Enclosed please find the comments of Catskill Mountainkeeper, Delaware Riverkeeper Network, Earthjustice, the Natural Resources Defense Council and Riverkeeper on the Revised Draft Supplemental Generic Environmental Impact Statement on the Oil, Gas and Solution Mining Regulatory Program, Well Permit Issuance for Horizontal Drilling and High-Volume Hydraulic Fracturing to Develop the Marcellus Shale and Other Low-Permeability Reservoirs, issued September 7, 2011, and draft regulations (Proposed Express Terms 6 NYCRR Parts 52, 190, 550-556, 560, 750.1, and 750.3), issued September 28, 2011.

RE: Technical Comments Summary Report: Expert Team Review of the 2011 Revised Draft SGEIS on the Oil, Gas and Solution Mining Regulatory Program and Proposed High-Volume Hydraulic Fracturing Regulations

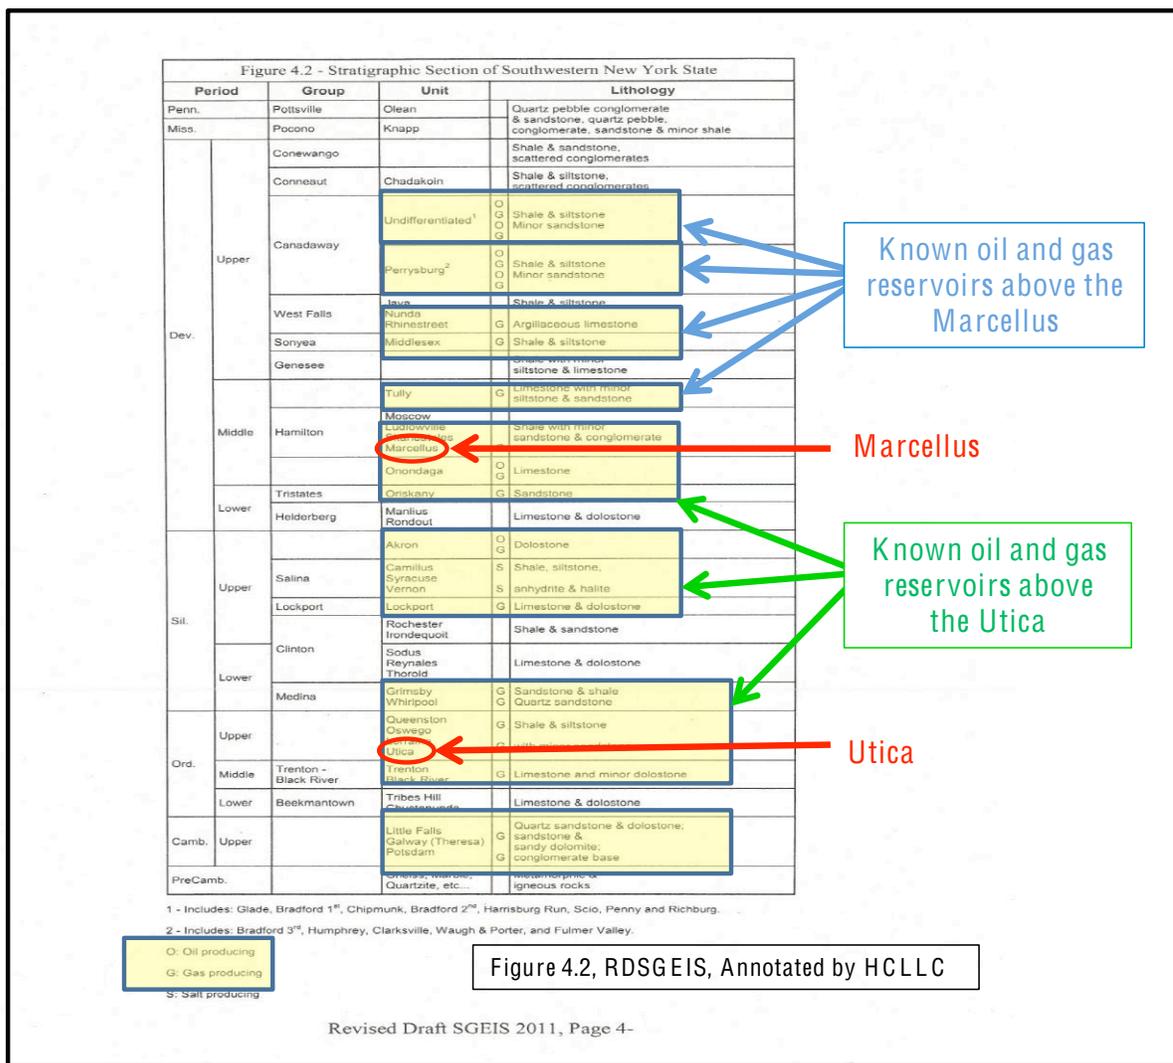
Using this definition, a low-permeability formation could include a shale, sandstone, limestone or other formation that is gas bearing with a permeability of less than 0.10 milidarcies. The RDSGEIS does not address the scope of the formations that could be encompassed by this definition.

Figure 4.2 of the RDSGEIS⁶ includes a stratigraphic section showing existing known oil and gas intervals above the Marcellus and Utica Shales, including numerous shale and other low-permeability formations that are known to exist, that were not examined in the SGEIS.

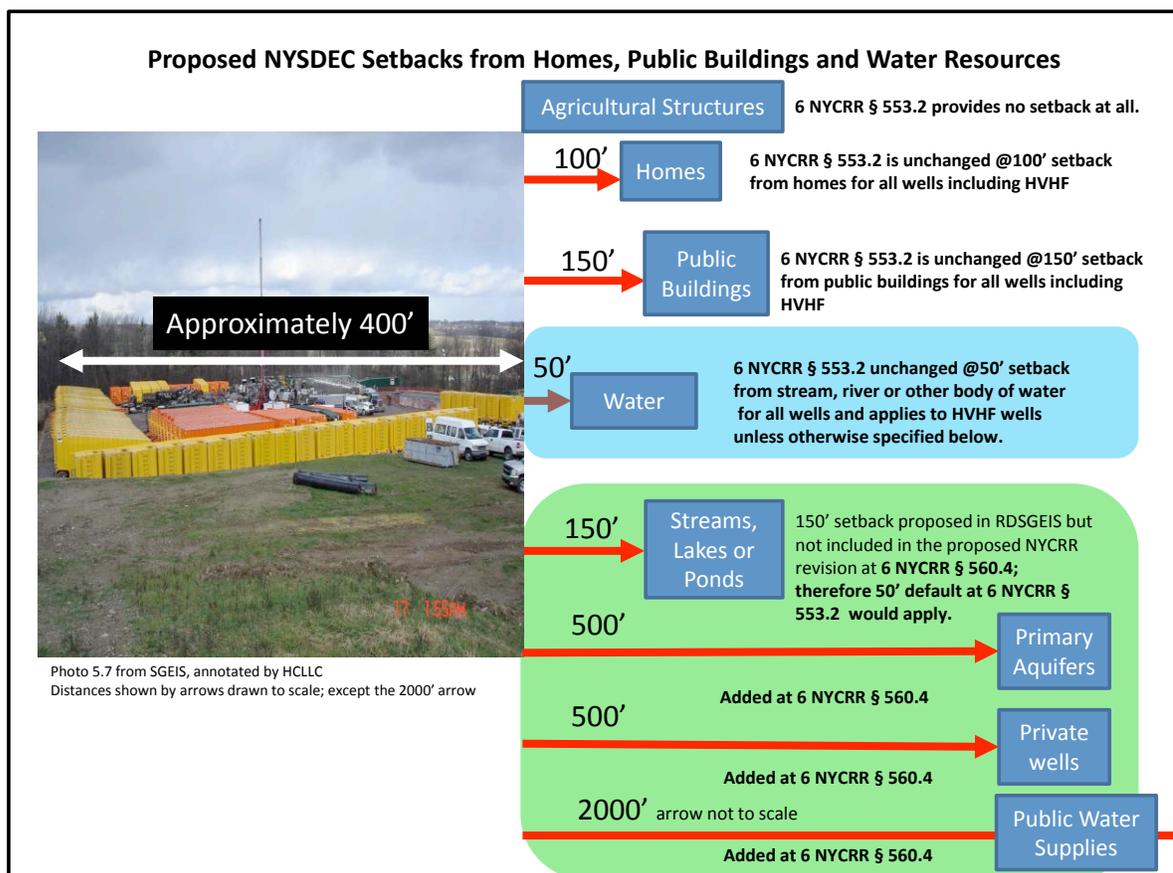
As shown in the figure below, the setbacks currently proposed in the RDSGEIS and in the NYCRR are inadequate. Shale drilling and HVHF operations within 100'-150' of homes and public buildings pose a direct safety risk, not to mention the health and quality of life impacts presented. NYSDEC is proposing

Recommendation No. 68: Improved setbacks should be included in the SGEIS as a mitigation measure and codified in the NYCRR. Specifically, the SGEIS and NYCRR should be revised at 6 NYCRR § 553.2 to include the following minimum setbacks: homes, public buildings, and schools (1,320'; ¼ mile); private and public wells, primary aquifers, and other sensitive water resources (4,000'); and other water resources (660'; 1/8 mile). Additionally, NYSDEC should clarify the authority of local zoning authorities to establish minimum setbacks that are more protective than NYS' minimum standards in order for localities to address unique and site-specific local concerns and community characteristics.

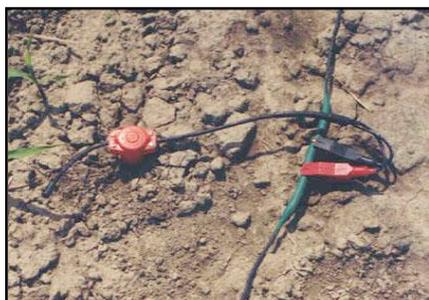
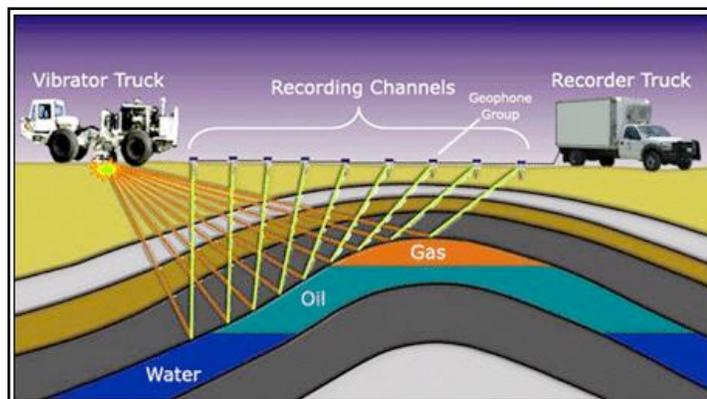
In January 2011, NYS' consultant, Alpha Geoscience provided a misguided recommendation to NYSDEC to ignore seismic data collection mitigation in the RDSGEIS, as "irrelevant."³⁹³ Because seismic data collection is typically the first step in unexplored areas, to locate and optimize exploration drilling targets, seismic data collection mitigation when used to target Marcellus Shale wells is hardly "irrelevant."

Therefore, it is unclear whether NYSDEC is not familiar with the use of seismic data collection to target hydrocarbon formations for drilling, and the mitigation measures needed because its consultants advised against study of this important mitigation, or whether shale gas operators have told NYSDEC that they don't intend to collect two-dimensional (2D) or three-dimensional (3D) seismic surveys prior to exploring in the Marcellus Shale.

If operators do not intend to collect additional 2D and 3D data, that representation should be stated in the RDSGEIS, and the 2D and 3D data collection should be precluded in NYS. Otherwise, the impacts of this work should be identified and mitigated. This is an important issue to resolve, because seismic surveys can create significant surface impacts and disruptions.

Recommendation No. 105: If 2D or 3D seismic surveys are planned, or are possible in the future, the NYCRR should codify a permitting process for these activities and institute mitigating measures in the SGEIS to minimize surface impacts and disruptions, and require rehabilitation of impacted areas.
